RAI Volume 3, Chapter 2.2.1.3.6, First Set, Number 2:

Explain how the TSPA seepage conceptualization and abstraction are consistent with observations and interpretations of the presence of liquid water in the Passive Test in the Enhanced Characterization of the Repository Block (ECRB) drift.

1. RESPONSE

Figure 2. Profiles of Evaporation (Condensation) Rate with Position in Emplacement Drift #7 from Condensation Model, Including Unheated Ends of Drift, at 10,000 Years after Closure

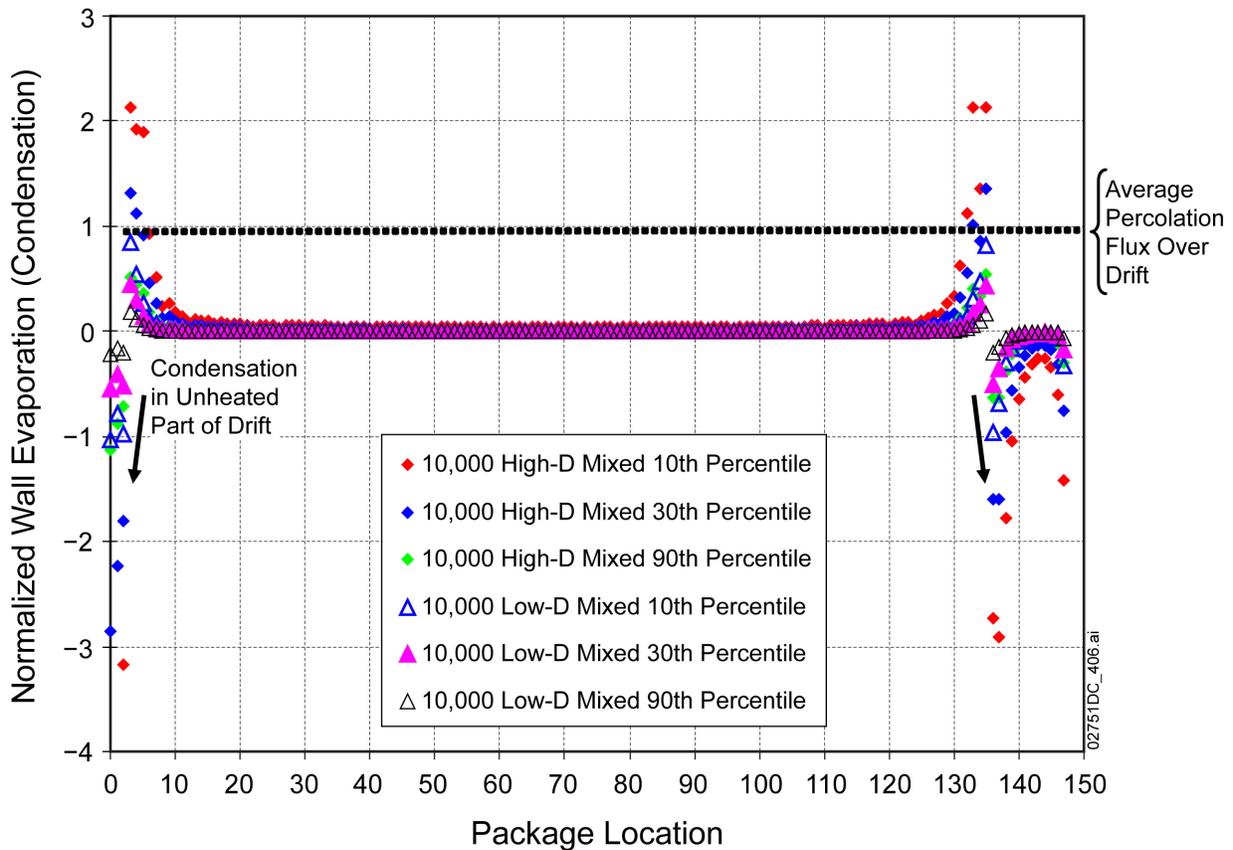
Explain how the volume of water entering a drift is not underestimated by the TSPA seepage abstraction, which neglects vapor migration into the drifts through fractures or other air pathways, redistribution within the drift, and subsequent condensation. See related RAI from Scenario Chapter, Set 5, RAI #3. This information is needed to verify compliance with 10 CFR 63.114(a), (c), (e), and (g).

The effect disappears later in time (Figure 2) when no condensation occurs in the heated part of the drift, and the rate of evaporation is substantially smaller. This occurs even though the condensation model uses a bounding, 100% relative humidity condition at the drift wall to represent availability of moisture for evaporation. This is because the rate of evaporation approaches zero throughout much of the drift (Figure 2). Near the ends of the heated region (where waste packages are emplaced) the evaporation rate remains high because the proximity to the unheated region allows the vapor to migrate away. This means that locally, the partial pressure of water is less than the equilibrium vapor pressure for the local temperature of the drift wall, driving evaporation. This effect does not lead to condensation in the emplacement area. The results described here were obtained even with the lower-bound dispersivity parameter representing low axial mobility of vapor (SAR Section 2.3.5.4.3.2.1).

Figure 1 Distribution of Quantile Position of Average Seepage per Percolation Subregion at (a) 10,000 Years and (b) 1,000,000 Years after Closure

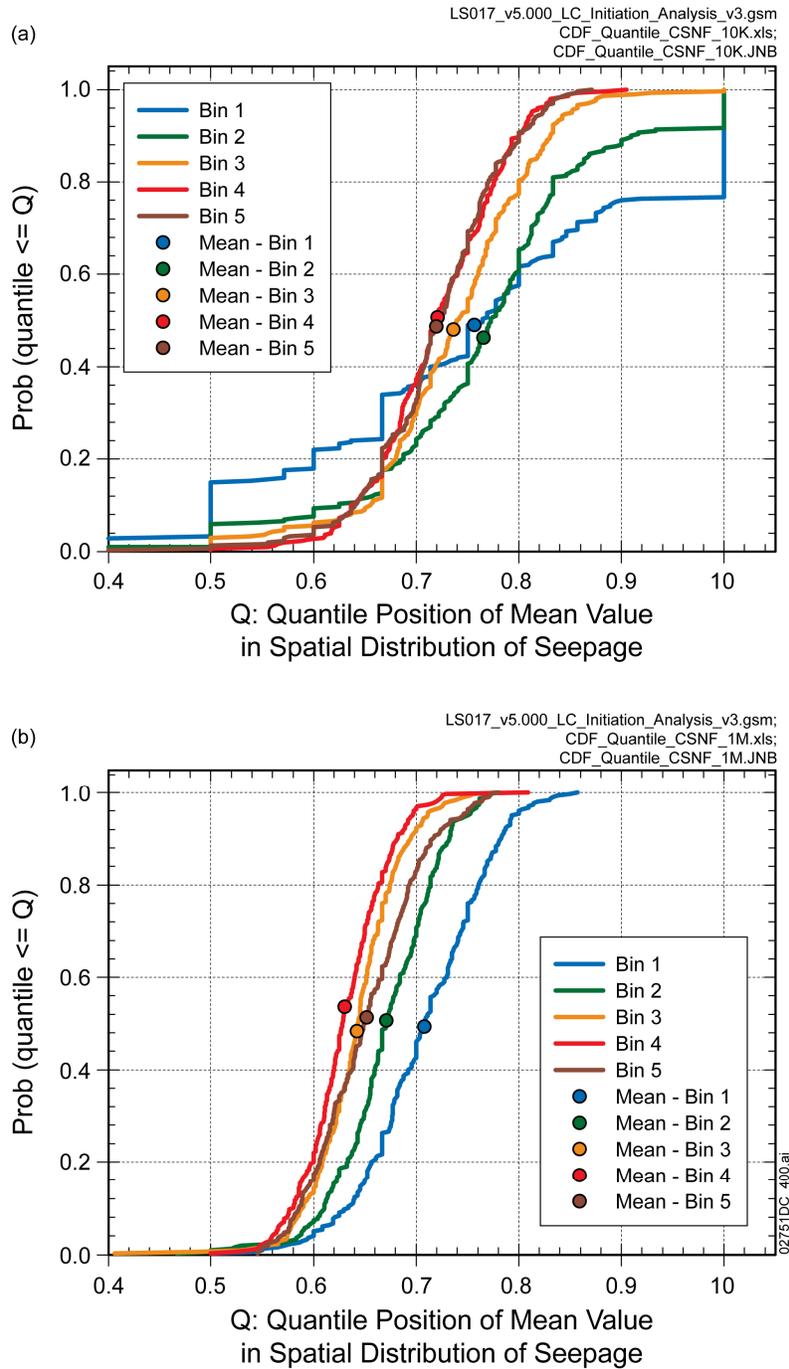
Explain how averaging seepage rates from individual waste package locations to create representative seepage rates for each percolation subregion impacts EBS radionuclide releases and doses. In addition, provide the technical basis for the assumption that five percolation subregions are sufficient to represent seepage and EBS release variability over the repository footprint. Consideration should be given to both the nominal and seismic ground motion scenarios. This information is needed to verify compliance with 10 CFR 63.114(b).

The spatial variability of seepage within each percolation subregion is summarized by the results presented in Figure 1, which shows CDFs of the quantile position of the average seepage rate within the spatial distribution of seepage. This probabilistic analysis considers an epistemic sample of size 300, as was used in the model. Figure 1 was made by calculating the seepage rate at 100 randomly selected MSTHM subdomain locations in each percolation subregion. For each sample element, the quantile position of the average seepage rate within the spatial distribution of seepage rate (for subdomain locations experiencing seepage rate greater than the threshold value of 0.1 kg/yr per waste package as described in SNL 2008a, Section 6.3.3.1.3) was calculated for each percolation subregion, and the distribution of these quantiles (over the epistemic sample) is shown in Figure 1. For all values of this distribution higher than 0.5, the spatial distribution of seepage is skewed to the right. Figure 1(a) shows that for 10,000 years after closure, the quantile position of the average seepage rate is above 0.5 in all subregions for

most epistemic sample elements; thus, the local seepage rate at most waste package locations in each subregion is less than the average seepage rate. A similar conclusion holds for 1,000,000 years after closure, as displayed in Figure 1(b).

Figure 1. Correlation between Seepage Fraction and Expected Annual Dose at (a) 10,000 Years and (b) 1,000,000 Years for the Seismic Ground Motion Modeling Case

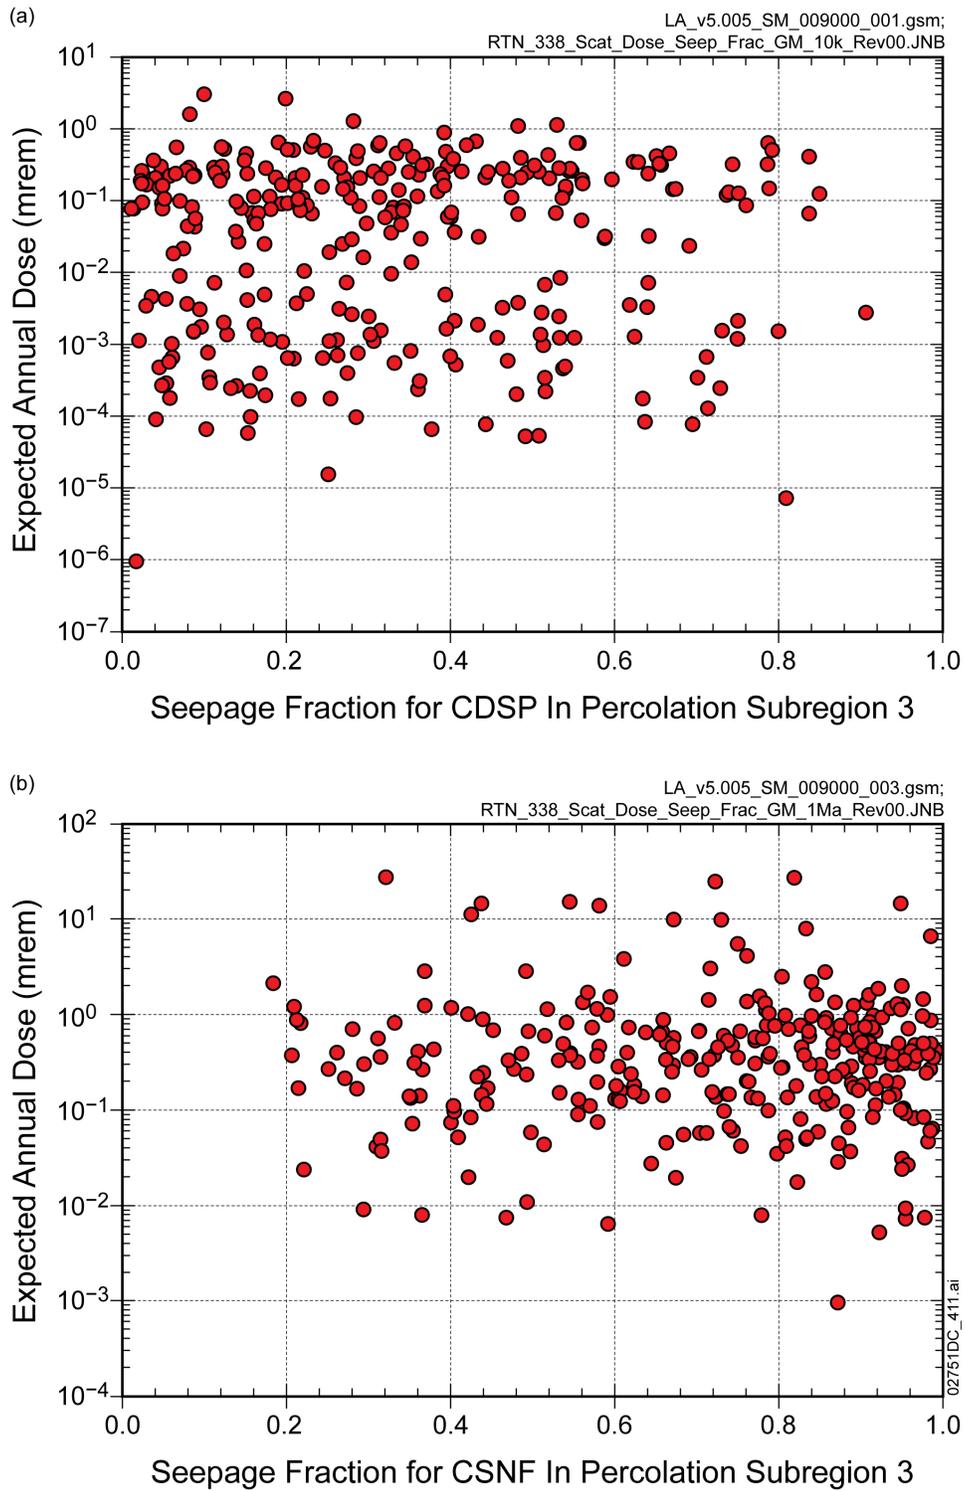
Also, spatial variability may be under represented, even if the two dimensional model appropriately characterizes flow in the TSw, when variability in flow at the base of the PTn is not fully considered. The model uses top boundary conditions that are either uniform or have regularly spaced sources. SNL (2007, Figure 6.6 13) suggests that fluxes calculated by the two dimensional model remain coherent at scales on the order of 10 to 20 m [33 to 66 ft], which can be interpreted as implying that flow variability at the base of the PTn at spatial scales as small as 10 m [33 ft] may increase flow variability at the drift scale. Several mechanisms may result in flow variability at this scale, such as (i) localized infiltration, (ii) local heterogeneity in the PTn, and (iii) episodic flow focusing into widely

The lack of sensitivity of repository performance to uncertainty in seepage fraction is demonstrated by Figure 1. Figure 1a shows the relationship between seepage fraction for codisposal waste packages in percolation subregion 3 and expected annual dose at 10,000 years for the seismic ground motion modeling case. As discussed in SAR Section 2.4.2.2.1.1.2, total mean dose to the reasonably maximally exposed individual (RMEI) for 10,000 years after permanent closure is dominated by contributions from the seismic ground motion modeling case, and this dose results from seismic damage to codisposal waste packages. For this demonstration, seepage fractions from percolation subregion 3 are selected, because this subregion comprises 40% of the waste packages in the repository. The variability in both seepage fraction and expected annual dose on Figure 1a results from epistemic uncertainty, because the expected annual dose has been integrated over aleatory uncertainty in seismic events. The lack of any correlation between seepage fraction and expected annual dose demonstrates that the mean annual dose for 10,000 years after permanent closure is not sensitive to the spatial variability in seepage represented by the seepage fraction. Rather, the uncertainty in the expected annual dose is dominated by epistemic uncertainty in the residual stress threshold for Alloy 22 (SAR Section 2.4.2.3.3.6), with minor sensitivities to other uncertain inputs (SAR Figure 2.4-149). Examination of other percolation subregions would reach a similar conclusion because the uncertainty in expected annual dose is not strongly influenced by uncertainty in quantities that vary between the percolation subregions (i.e., seepage fraction). Moreover, the results shown in Figure 1a cover most of the range of seepage fraction (nearly 0 to greater than 0.8) that is observed in the other percolation subregions.

Figure 1b shows the relationship between seepage fraction for commercial SNF waste packages in percolation subregion 3 and expected annual dose at 1,000,000 years for the seismic ground motion modeling case (which includes the effects of nominal processes). As discussed in SAR Section 2.4.2.2.1.1.2, total mean dose to the RMEI at 1,000,000 years after permanent closure results is comprised of roughly equal contributions from the seismic ground motion modeling case (which uses the seepage abstraction) and the igneous intrusion modeling case (which does not use the seepage abstraction). Moreover, in the seismic ground motion modeling case, the expected annual dose after about 500,000 years after permanent closure is dominated by releases from commercial SNF waste packages, which in turn results primarily from waste package failures associated with nominal processes. The lack of any correlation between seepage fraction and expected annual dose demonstrates that the mean annual dose at 1,000,000 years after permanent closure is not sensitive to the spatial variability in seepage represented by the seepage fraction. Rather, the uncertainty in the expected annual dose is dominated by epistemic uncertainty in the temperature dependence coefficient associated with the general corrosion rate for Alloy 22 (SAR Section 2.4.2.3.3.6), with minor sensitivities to other uncertain inputs (SAR Figure 2.4-151).

Figure 1. Comparison of the Cumulative Distribution Functions of Spatially-Averaged Percolation Rate per Commercial SNF Waste Package during the Glacial-Transition Climate for the GLUE-weighted and Unweighted Analyses

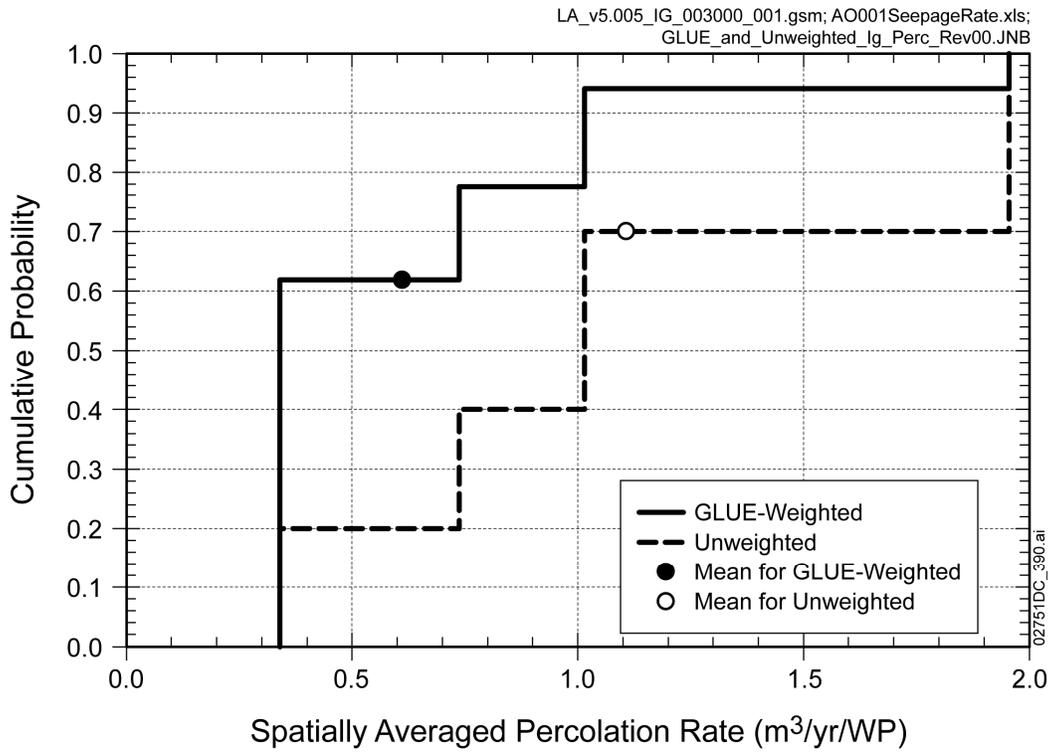
Basis: The GLUE procedure results in a set of weights applied to the infiltration scenarios (SAR Section 2.3.2.4.1.2.4.5.5). These weights yield lower expected mean annual infiltration than the original weights provided in SNL (2008). The SAR and supporting documents do not clearly describe how performance changes when the infiltration scenario weights are modified using the GLUE procedure. Therefore, it is not possible to evaluate the effects of the GLUE-derived weights on seepage, release, and transport.

The unweighted case results in higher likelihood of larger values of *INFIL* (Table 1), which corresponds to greater mean annual net infiltration, and consequently higher likelihood of greater average percolation flux. Figure 1 compares the distributions for the repository average percolation rate per waste package during the glacial-transition climate for the GLUE-weighted and unweighted analyses. Each distribution shown on Figure 1 consists of four discrete values because these results have been averaged spatially within each percolation subregion and over the five percolation subregions. The uncertainty in these results arises only from the selection of the infiltration case. Higher percolation rates are more likely in the unweighted analysis, which leads to an increase in the mean repository average percolation per waste package during the glacial-transition climate by a factor of about 80%, from 0.61 to 1.1 m³/yr. For all climate states, Table 2 shows the increase in mean percolation flux at the base of the Paintbrush nonwelded (PTn) unit over the repository footprint resulting from the use of unweighted distribution for *INFIL*. Note that the average infiltration fluxes (Section 1.1) and percolation fluxes (Table 2) over the repository footprint are not necessarily equal because of the following three factors:
